STATE OF NORTH CAROLINA
DEPARTMENT OF TRANSPORTATION

Subject: **1) Section 404 Nationwide Permit 3/33 & 401 Individual Water Quality Certification** for the “Upper Section” of NC 9 (from “Station 37” to the Buncombe County Line).
2) Modification to Site 1 of the previously issued permits for the “Lower Section” (NC 9 from US 74A to Station 37).
3) Additional Information pursuant to questions from the September 5, 2025 project “walk-thru”
Henderson County, Division 14, WBS 18314.1045061.

Reference: 404 Permit; Action ID: SAW-2025-00325, dated 8/8/2025.
401 Certification; Project No. 20250664, dated 8/4/2025.

The North Carolina Department of Transportation (NCDOT) provides the following supplemental information, provided to answer question and provide additional information after the September 5, 2025 “virtual walk-thru” for the above referenced project.

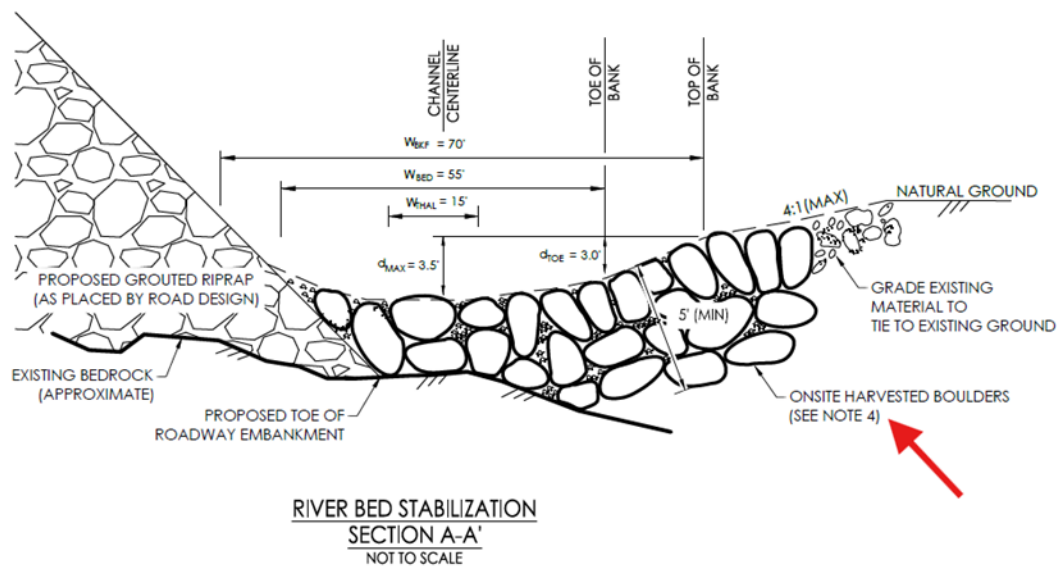
David McHenry (NC WRC): The application mentions the river bed is bedrock, but it also notes; All river material will consist of previously harvested river material which was deposited in upland areas and temporarily used to re-stabilize NC 9, on Sheet 4. Specifically, where is that material coming from? Is it the excavated road bed material in the attached picture (left side) where the single lane NC 9 has been (may still be)? I haven't been down there in a while so I'm not sure what other changes may have occurred down there in last 2-3 months.

Response: Here's an excerpt of the attached in-stream construction detail. Boulders will be harvested on-site along the river including using what's remaining of the temporary berm that was built right after the storm that allowed them to build the temporary gravel "road" right after the storm. Coincidentally, the stream morphologists recommended that these boulders be removed because they were causing a high energy concentration that wasn't present in the river pre-Helene so they will be beneficially used to stabilize the river.

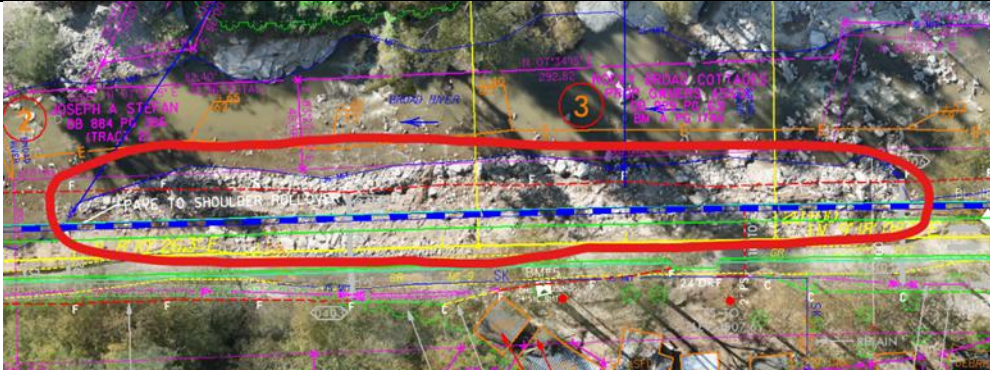
Boulders outlined in red below will be used in Site 1.

Note 4 will allow the contractor to use non-native boulders in the lower layer topped with the harvested layer if there are not enough harvested boulders.

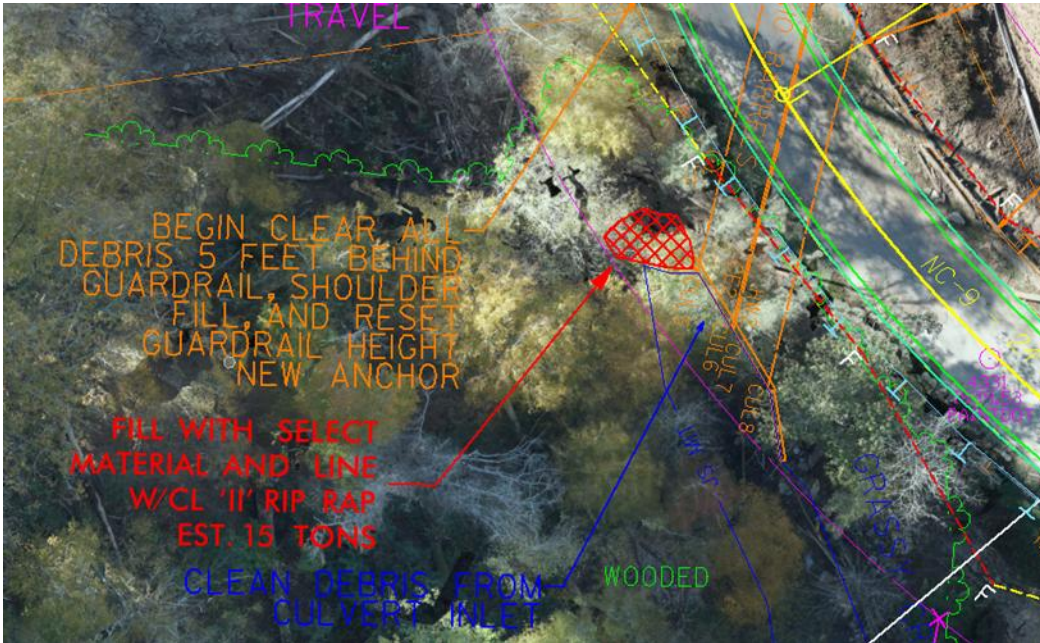
David McHenry (NC WRC): Also, at site 7, is that short class II section the fill planned to fix to the RCBC perch (and stabilize the right bank)? Attached is a picture of this area.

Response: At the Inlet, we proposed to place Class II Rip Rap behind the wingwall to repair some Helene erosion.

At the Outlet, we propose to place Class II Rip Rap in the creek to repair the perched culvert. As requested in the meeting, we have prepared a detail that will direct the contractor to channelize this rip rap.

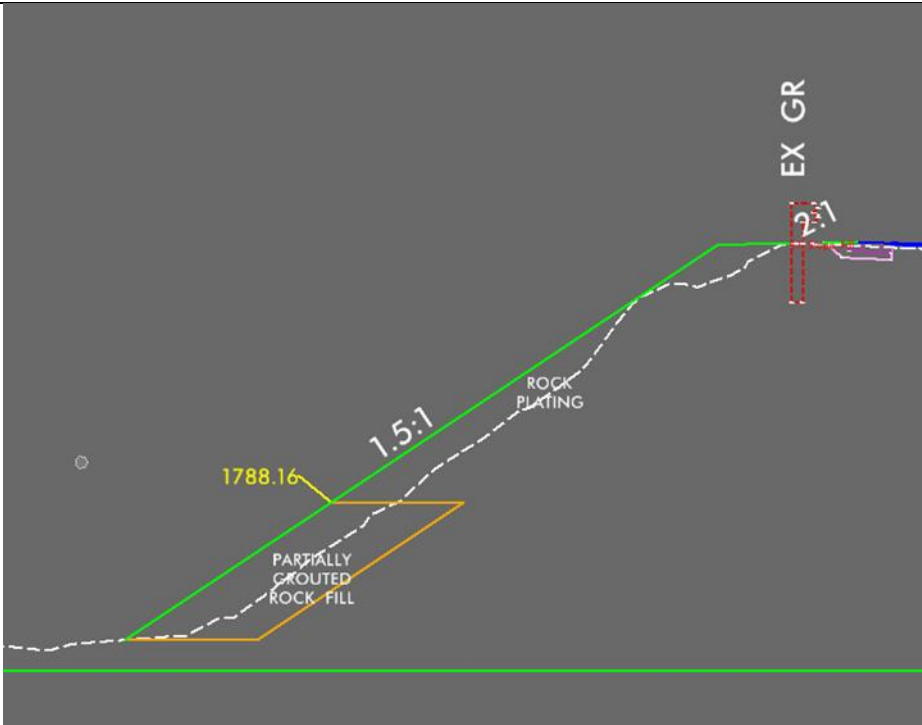
David McHenry (NC WRC): And, what is the stabilization material and the profile (x-secs available?) proposed to extend 400 feet or so downstream? I didn't see (but may have missed) a description/detail.

Response: Downstream from the outlet will be repaired using the same method we used along the Broad River. The stabilization material will be grouted Class VII rip rap at the toe of the slope and Class II rip rap on up the slope where it is Rock Plating as detailed in the Geotechnical portion of the plans. See below for a typical cross section at station 62+50.

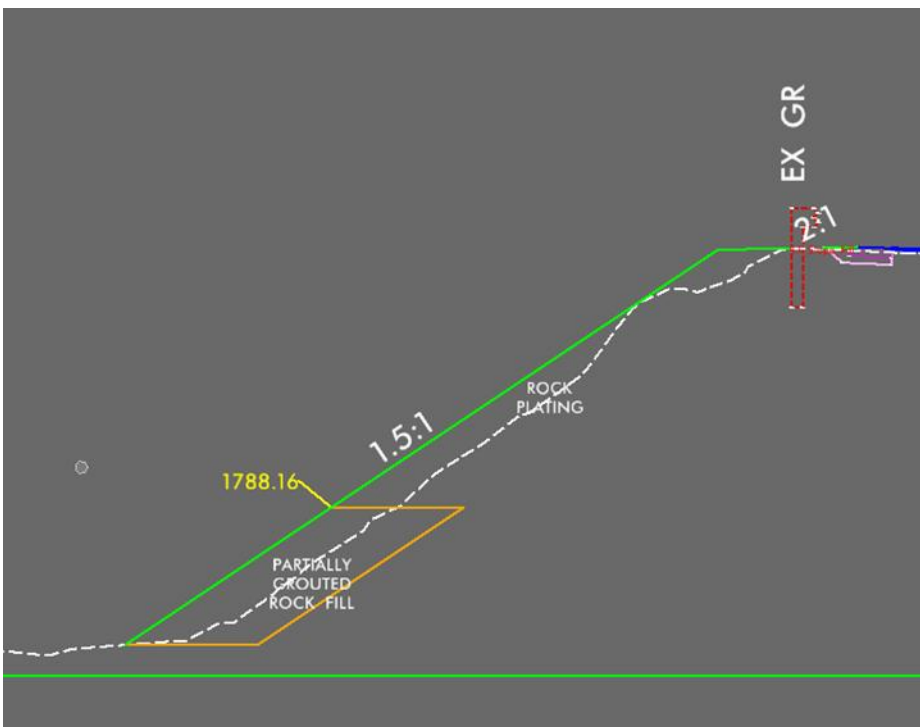
David McHenry (NC WRC): Anyway, if they go with another grouted embankment here, they should replace those very abundant boulders that are in the active channel (see photos) to retain some existing habitat complexity, like the approach recommended at site 1. I'd hate to see that converted to ditch-like cross-section.

Response: As shown in the cross section at Station 62+00 below, it is not NCDOT's intention to disturb the boulders that are in the stream bed of Grassy Creek shown in your photos, only stabilize the roadside fill slope and not go beyond the pre-Helene edge of creek. From your pictures, we believe grass has grown from the hydroseeding and that grass is hiding some of the damage that needs to be repaired underneath. See photos below. The roadway and geotechnical engineers believe that these unstable areas need to be protected with rip rap.
